**OFFICE OF ENERGY INFRASTRUCTURE SAFETY**

Enclosed is the Final Action Statement on the 2021 Wildfire Mitigation Plan (WMP) Update of Southern California Edison Company (SCE).

**FINAL EVALUATION OF 2021  
WILDFIRE MITIGATION PLAN  
UPDATE**

**SOUTHERN CALIFORNIA EDISON**

Figure 1: SCE’s Ignitions Against Risk Buydown<sup>98</sup>

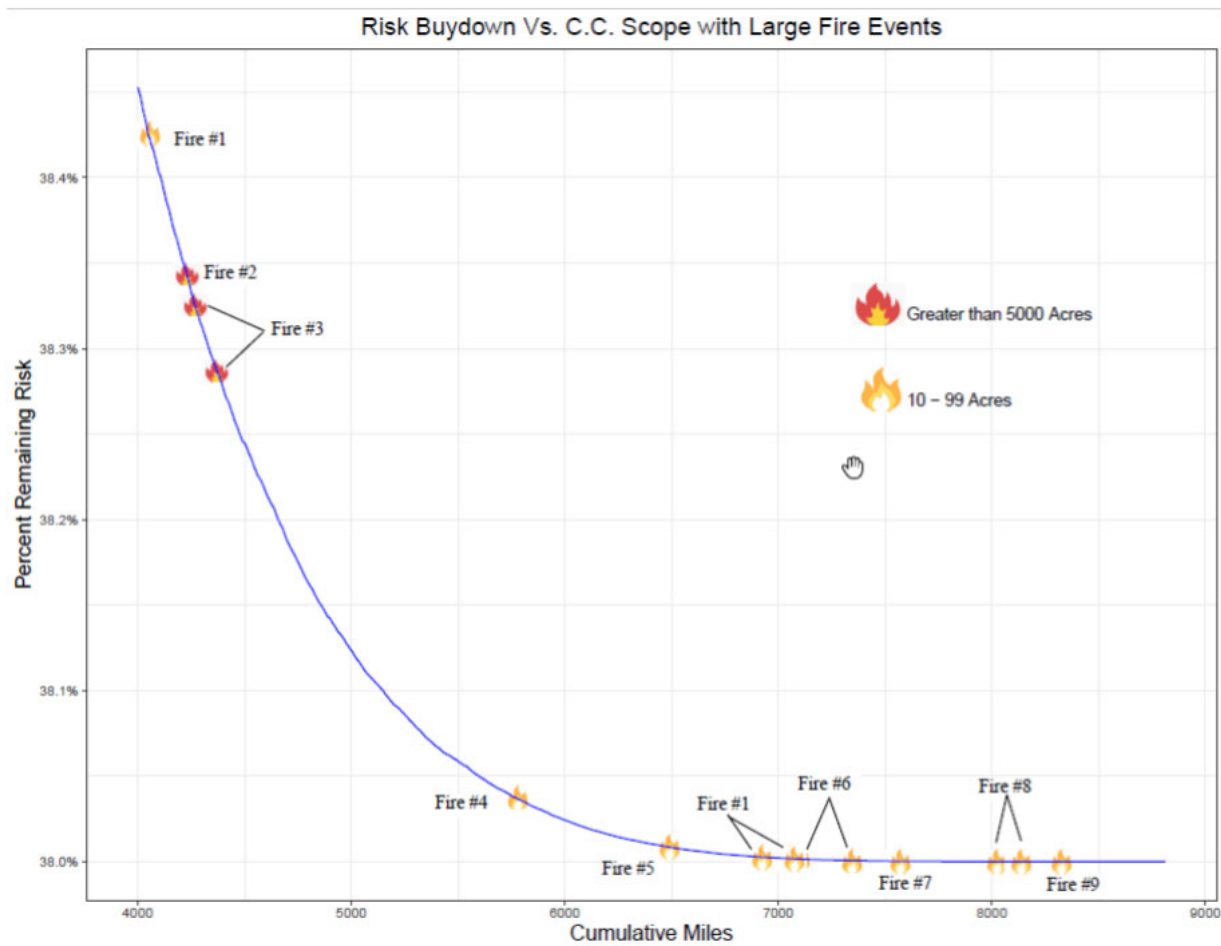
SCE justifies its extensive plan for covered conductor with a graph (see Figure 1 below) showing that destructive wildfires have recently occurred in SCE's service area on circuit-segments located in areas "further down the risk buydown curve that would remain uncovered under a more limited deployment scenario."<sup>93,94</sup> However, SCE does not provide enough information to adequately demonstrate the need for covered conductor for circuits ranked as lower risk by SCE's own risk ranking. For one, SCE does not identify the cause of each ignition, thereby making it impossible to determine if covered conductor would have prevented or reduced the likelihood of the ignition from occurring. This omission is particularly relevant given that SCE calculates that covered conductor installation reduces risk by only 64% and does not account for all ignition drivers.<sup>95</sup> SCE also fails to acknowledge that the majority of ignitions within SCE's service territory are caused by third-party contacts,<sup>96</sup> as covered by SCE-21-10 in Section 5.1. Lastly, the graph is based on SCE's previous risk model, used in 2020. While SCE states that "the concepts remain unchanged and valid,"<sup>97</sup> SCE must reassess risk based on its current risk assessment model including consequence, introduced in 2021, and reflect upon the accuracy of model outputs if actual risk is occurring beyond its own cumulative risk mile assessment. This is addressed in SCE-21-05 in Section 5.3.

<sup>94</sup> Figure SCE 9.10-1 of SCE's 2021 WMP Update - Redlined shows that two fires greater than 5000 acres and 7 fires 10-99 acres in size occurred beyond the 2,110 cumulative mile risk ranking

SCE-21-05	Out-dated risk assessment used to justify the selection and scope of covered conductor as a mitigation initiative	SCE provides a risk buydown curve based on its old modeling efforts to justify the need for covered conductor. SCE acknowledges that its current models provide different and more accurate results but does not provide an updated risk buydown curve. SCE should not use outdated information to justify its covered conductor program scope. Additionally, if an updated risk buydown curve	SCE must: 1. Provide an updated Figure 9.01-1 based on SCE's latest risk modeling assessment, including the ignitions shown. 2. Provide the cause of the 9 ignitions shown in Figure 9.01-1. 3. For each of the nine ignitions shown, provide an assessment of the likelihood that covered conductor installation would have prevented the ignition.
